The Sizewell C Project, Ref. EN010012

Suffolk County Council Written Representation

Deadline 2

2 June 2021

Figure 3: Plan of the proposed SZC site showing postulated routes for GIL connections. Areas where GIL could not be installed (in troughs or above ground) are shaded.

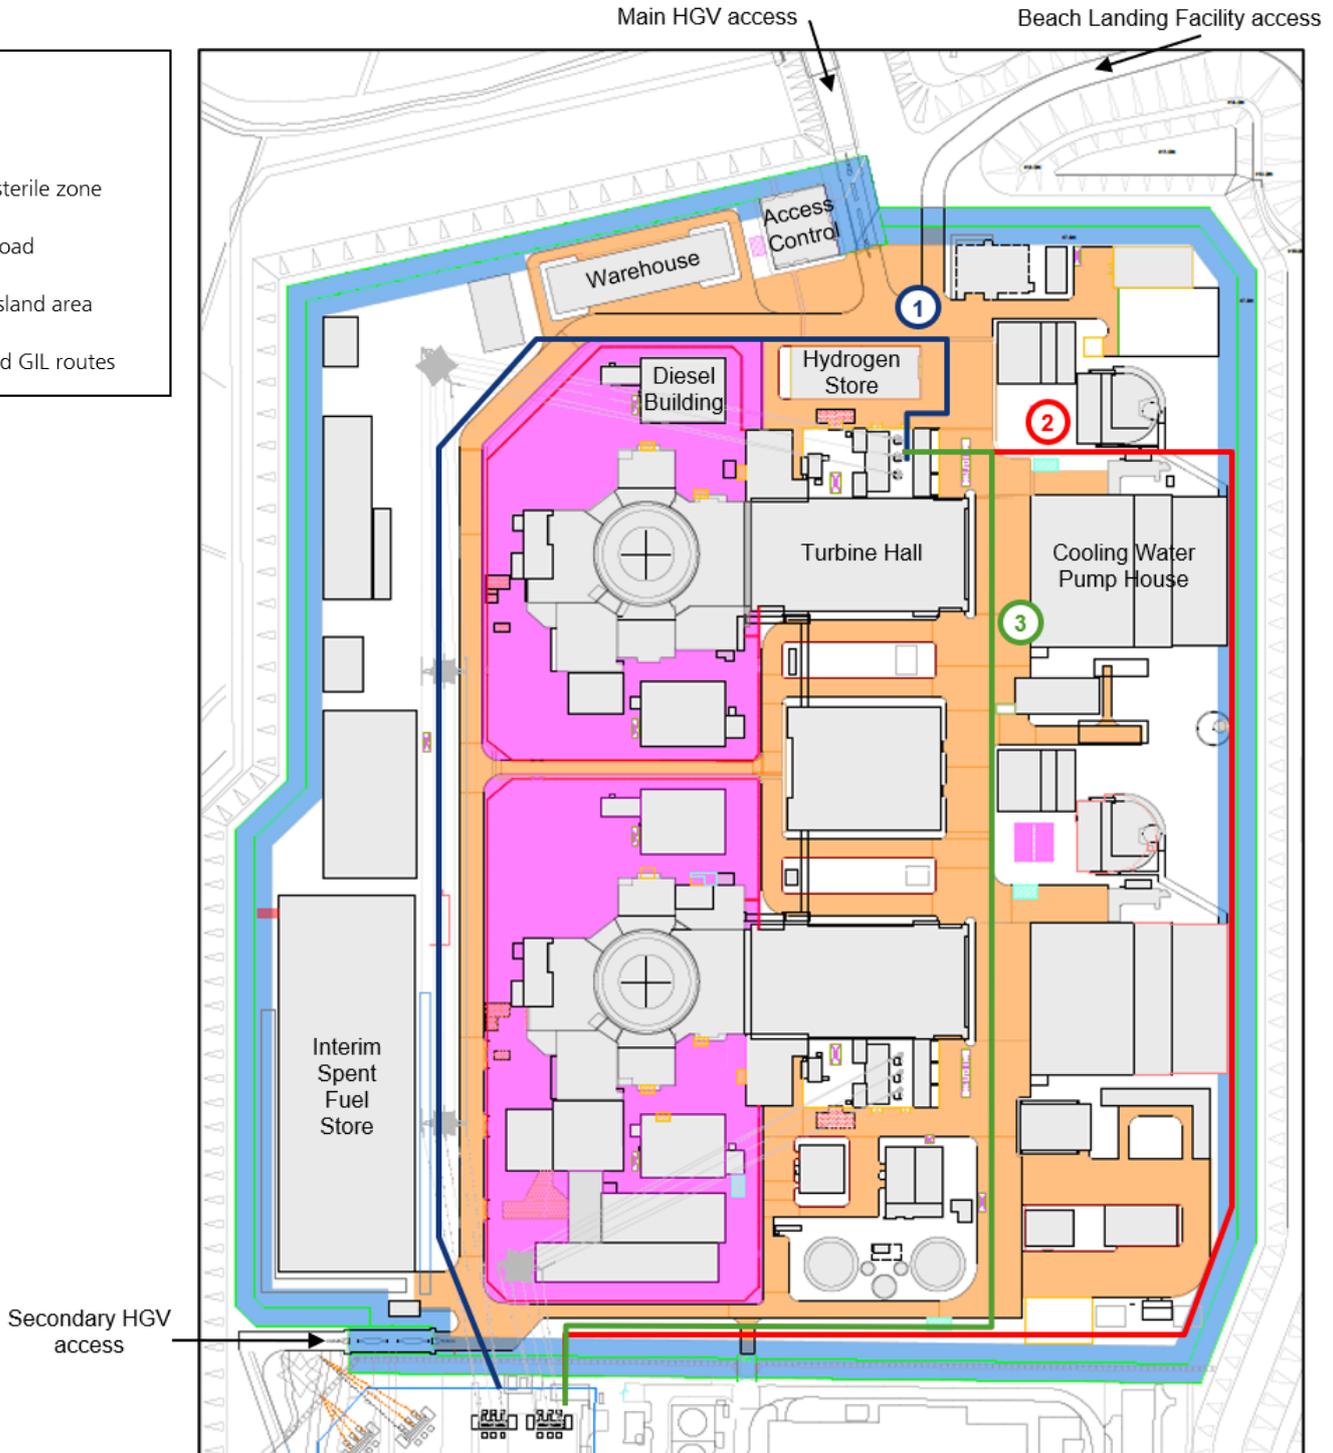
The plan in Figure 3 indicates three approximate 'corridors' through the site which could be considered for GIL routing:
